Department of
Resources Recycling and Recovery

Subject: Review of the November 26, 2024, Revised Soil Reaction Break/Barrier Plan for the Chiquita Canyon Landfill Subsurface Elevated Temperature (SET) Event

Technical Memorandum from Dr. Stark dated February 26, 2025

RE: Comments on November 26, 2024 Revised Soil Reaction Break/Barrier Plan and February 20, 2025 waste temperature data for Chiquita Canyon Landfill Subsurface Elevated Temperature (SET) Event

Figure 2. Extent of elevated temperatures from March 27, 2024 to February 26, 2025.

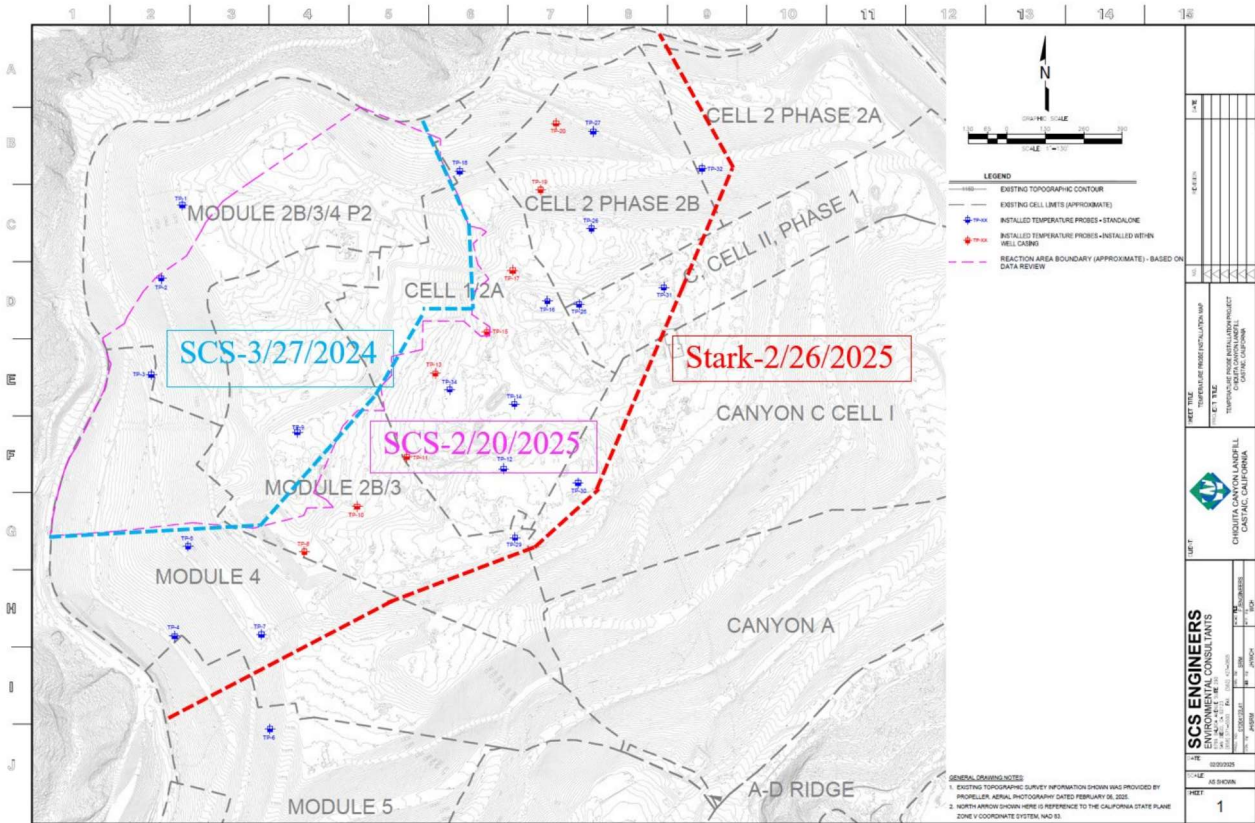
Figure 2 presents Sheet #1 from the SCS Report that presents the Waste Borehole Maximum Temperature Profiles Over 6 Weeks from January 9, 2025 to February 19, 2025.⁷ The dashed pink line represents the extent of the SET Event as determined by SCS on February 20, 2025. This extent is slightly larger than the dashed blue line, which represents the extent of the SET Event on March 27, 2024 as reported by SCS in the initial Soil Reaction Break/Barrier Plan.⁸ **Figure 2** also presents my extent of the SET Event as of February 26, 2025 (see dashed red line) based on the Waste Borehole Maximum Temperature Profiles Over 6 Weeks from January 9, 2025 to February 19, 2025.⁹ **Figure 2** shows the western slope and entire top deck of the CCL is now part of the

SET Event, which is a significant increase over the extent reported by SCS on March 27, 2024¹⁰ and February 20, 2025.¹¹ Based on **Figure 2**, SCS believes the SET Event only covers about 28 acres as of February 20, 2025 whereas my extent of the SET Event covers about 90 acres.

Figure 7. Extent of elevated temperatures on February 26, 2025 and location of a possible vertical barrier to isolate southernmost 13 acres.

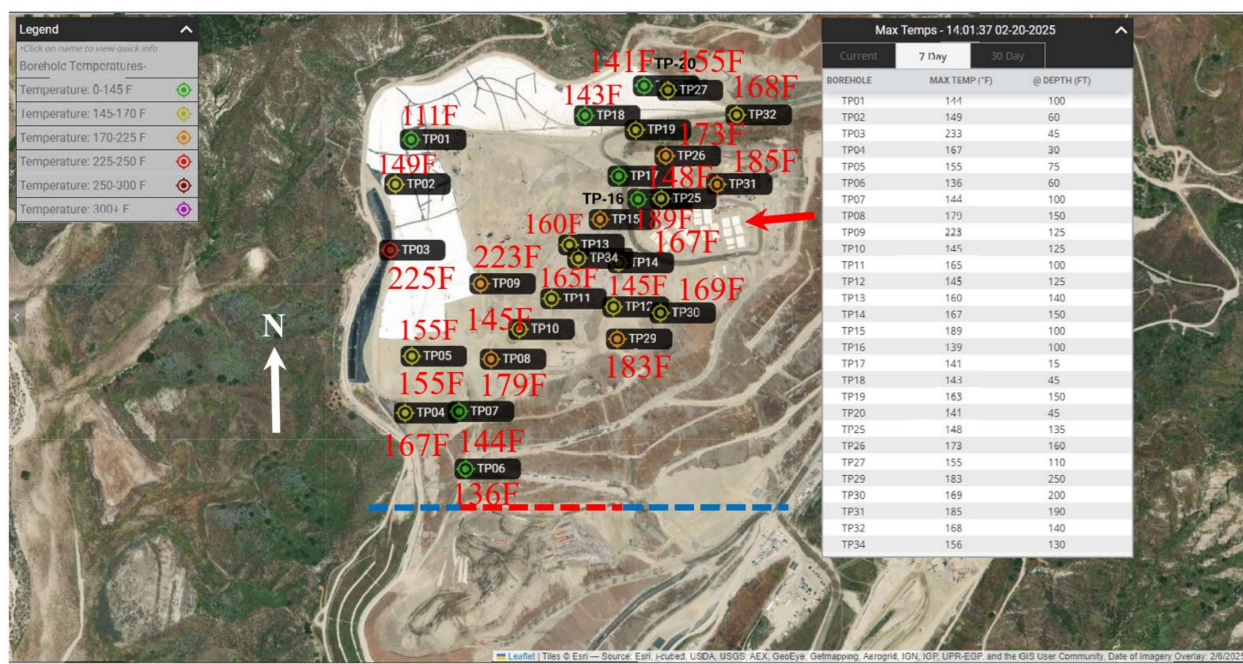
Given the west side and top deck of the CCL are experiencing elevated temperature, I unfortunately think the only remedial option is to cover the entire landfill north of TP06 or north of the red and blue dashed line shown in **Figure 7**. The elevated temperatures have not manifested themselves on the eastern slope yet, but I anticipate leachate outbreaks could start occurring because elevated temperatures (183⁰F and 185⁰F as shown in **Figure 1**) are present at the crest of the eastern slope.

This section discusses installing a thermal barrier south of TP06 (see dashed red and blue line in **Figure 7**). A thermal barrier is recommended along the dashed red and blue line in **Figure 7** for at least the following reasons:

- CCL is using the approximately 13 acres south of the dashed red and blue line in **Figure 7** for disposal operations so elevated temperatures should be prevented from reaching this area, so the landfill continues to have an area to dispose of on-site wastes.
- Ensure continued ingress and egress from the CCL.
- Reduce the amount of waste that can be consumed by the SET Event and thus reduce the duration of odors and emissions to the surrounding communities.
- Maintain stability of the southern sideslope.

The red dashed line in **Figure 7** roughly delineates the location of a thermal barrier already constructed by CCL. The extent and depth of the thermal barrier are not known, so I request this information be provided by CCL. The blue dashed lines in **Figure 7** indicate the existing thermal barrier should be extended east and west so the SET Event cannot go around or under the existing thermal barrier.

exposed EVOH geomembrane over the area to the north of the red and blue dashed line shown in **Figure 7**.

5. Submit a Request For Information (RFI) regarding the current extent and depth of the thermal barrier installed near the southern end of the CCL (see red dashed line in **Figure 7**), and

Figure 8. Possible configurations of 3 to 4 ft diameter vertical elements to comprise a heat barrier system south of TP06 to isolate southernmost 13 acres.

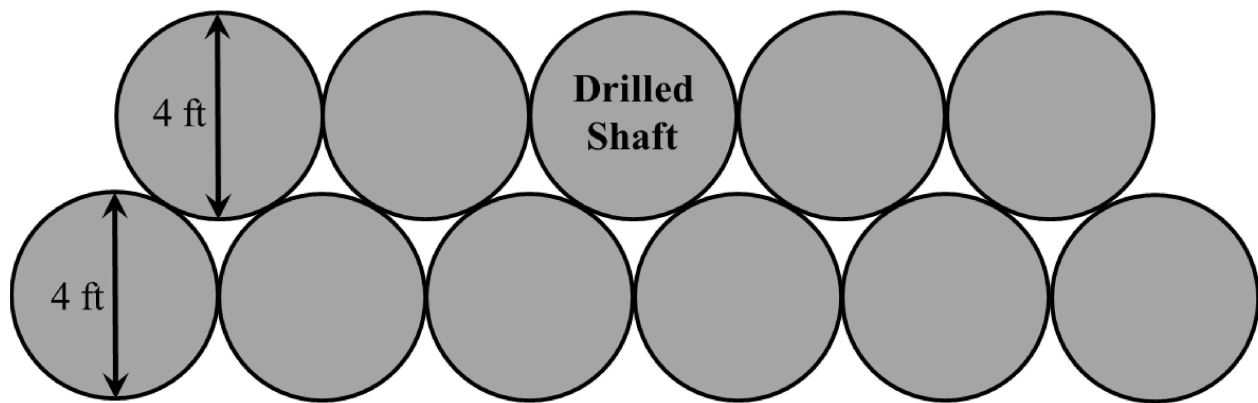
If the existing thermal barrier does not extend to near below the leachate level, vertical elements can be used to create a vertical thermal barrier to prevent the SET Event from impacting the southernmost 13 acres of the CCL. The vertical elements involve excavating a vertical shaft using a three or four-foot bucket auger drill rig, which is being used to install gas extraction wells at CCL. These vertical elements would be constructed along the dashed red and blue lines in **Figure 7**. After excavating the shaft, it could be backfilled with a soil-bentonite or soil-cement mix. The shafts would be tangent, i.e., touching, or overlapped (see **Figure 7**) to create a continuous barrier across the toe of the southern sideslope to prevent the SET Event from consuming the southernmost 13 acres. If heat transfer calculations require a wider thermal barrier, a second row of vertical elements could be constructed north or south of the initial row (see **Figure 7**). The secondary row would be tangent to the initial row and be centered at each intersection of the initial row as shown below (see **Figure 7**).
